EARLY DESIGN GUIDANCE OF THE DOWNTOWN DESIGN REVIEW BOARD

Project Number: 3012542

Address: 2217 3rd Avenue

Date of Meeting: Tuesday, December 13, 2011

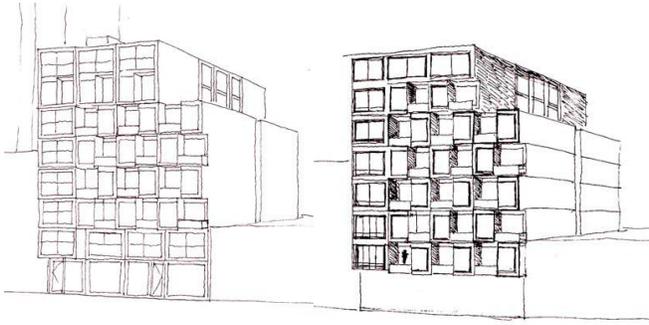
At the Early Design Guidance Meeting, the Board discussed the appearance of the street-facing façade for Alternate 3. The upper level units were shown stepped back from the north property line, and the Board felt that this didn't contribute to a well-proportioned street facing façade. The Board suggested reorganizing the upper level floor plan to create a consistent street-facing façade, similar to Alternate 2. Overall, the Board was supportive of the preferred Alternate 3 with this modification.

The Board expressed appreciation for the preliminary façade sketches for Alternate 3 and they looked forward to seeing more detail at the Recommendation stage. The Board directed the applicant to design the variations in the façade to provide real physical depth and variation within the modules, and use different colors or materials to express the variations. The challenge will be to use colors/materials/shapes to create a unified design across the modules.

The Board indicated that Alternate 3 is the preferred massing, with modifications to the street wall as described in response to Guideline B-4. However, if the applicant elects to proceed with Alternate 1, the Board would continue to entertain this proposed departure.

- 2. Street façade requirements (23.49.162):** The Code requires a maximum façade setback, and a minimum of 10' between those façade setbacks. The applicant proposes in Alternate 3 to provide 8' between façade setbacks, which will allow for decks that are recessed from the façade.

The Board indicated they would continue to entertain this departure at the Recommendation stage of review. The detailing of materials, colors, and façade setbacks will need to create a unified design, as described in response to Guideline B-4. The separation between façade setbacks could vary in width, if the result is a better overall design.
